Amendments to the Drawings:

This is in response to the office action of July 13, 2005.

Appl. No. 10/771,152
Amdt. Dated October 7, 2005
Reply to Office Action of July 13, 2005

FIG. I PRIOR ART

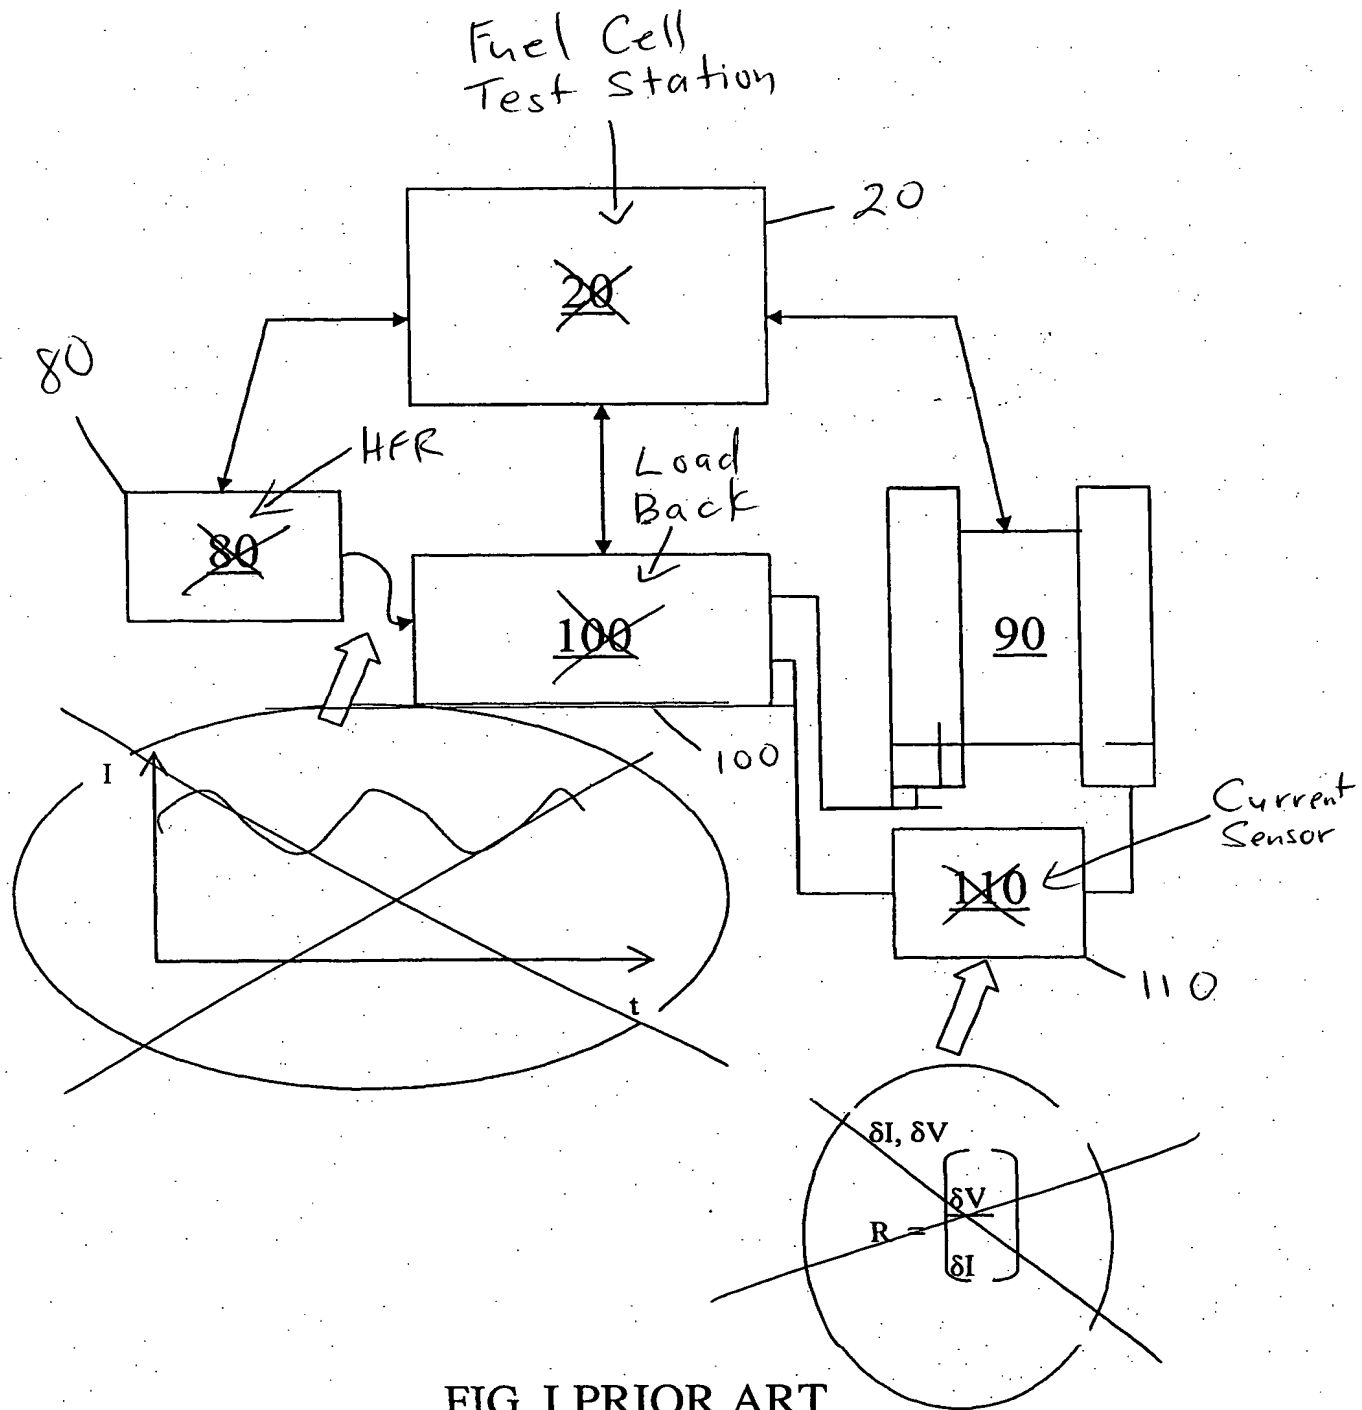
In addition, the Examiner objected to Figure 1 on the basis that it did not include short descriptive labels for the blank boxes.

In response to the Examiner's objections to Figure 1, descriptive labels have been added to the formerly blank boxes of Figure 1. Support for these amendments can be found in paragraph 32 of the specification. In addition, Figure 1 has been amended to remove an equation, and a graph, formerly shown.

FIG. 2a

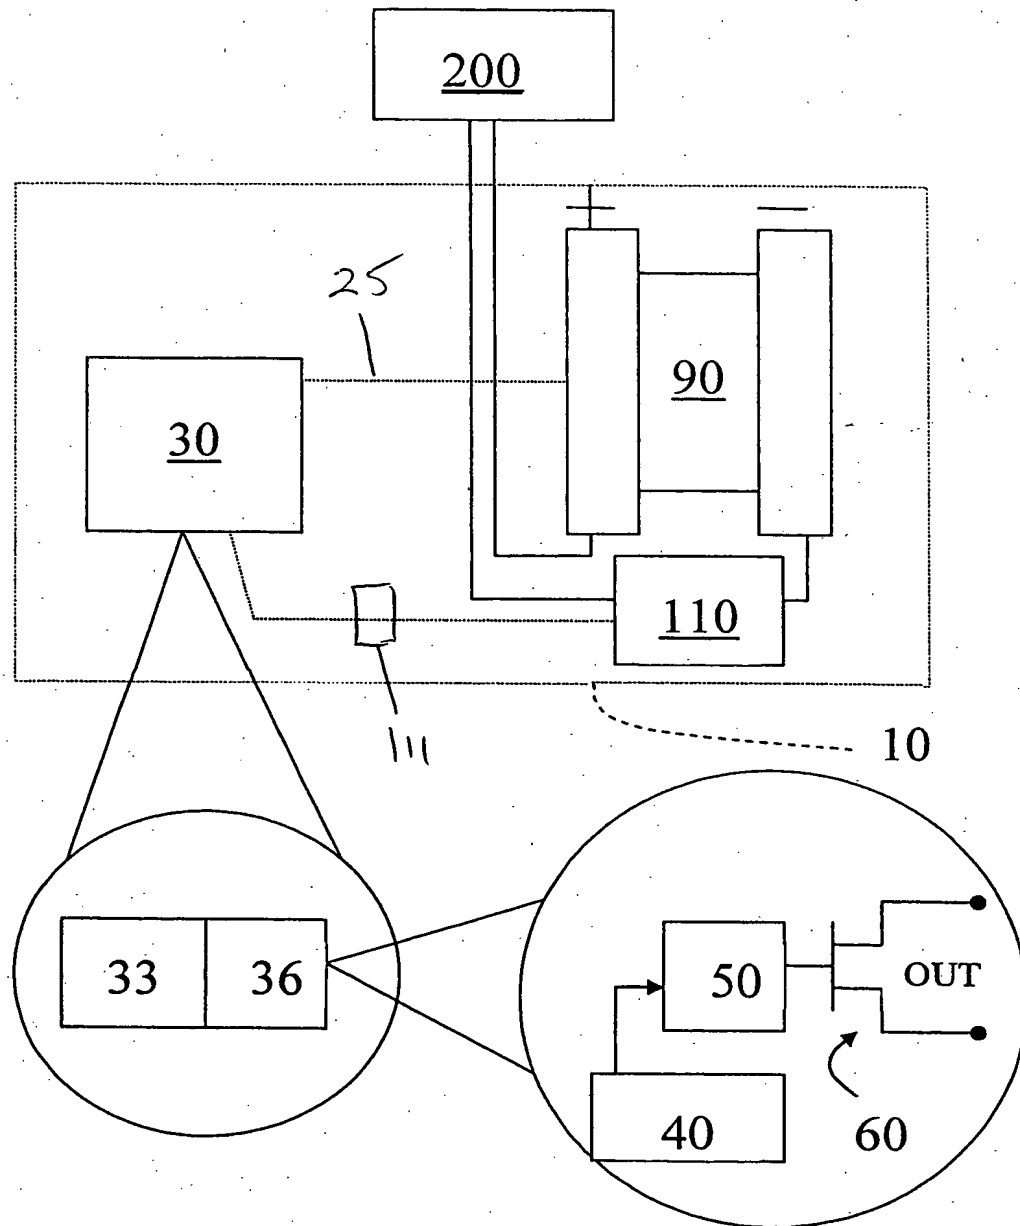
In paragraph 1 of the Office Action, the Examiner took the position that a number of features of the invention as specified in the claims should be added to the drawings. In particular, the Examiner stated that "the plurality of primary channels", "a splitter", "second channels", "a plurality of instrumentation amplifiers", an analog multiplexer", "a first analog to digital converter", "a voltage data bus", "a current amplifier", "an analog and digital control", "a computing device", and "a plurality of differential amplifiers" must be shown in the drawings or, alternatively, such features could be cancelled from the claims.

In response to the Examiner's objections to the drawings for failing to show features of aspects of the invention specified in the claims, Figure 2a has been amended to

show a current amplifier 111. Support for this amendment is provided by paragraphs 36, 45 and 46, which paragraphs have also been amended to include the reference numeral 111 with the term "current amplifier".

In addition to the above-described amendment, Figure 2a, as well as Figure 2b, have both been amended to add reference numeral 25, which designates the plurality of inputs. Support for this amendment is found in paragraph 11 and 35, as well as in claims 1 and 4 of the application as filed. Paragraphs 35 and 43 of the specification have also been amended to include reference numeral 25 to designate the "plurality of inputs".
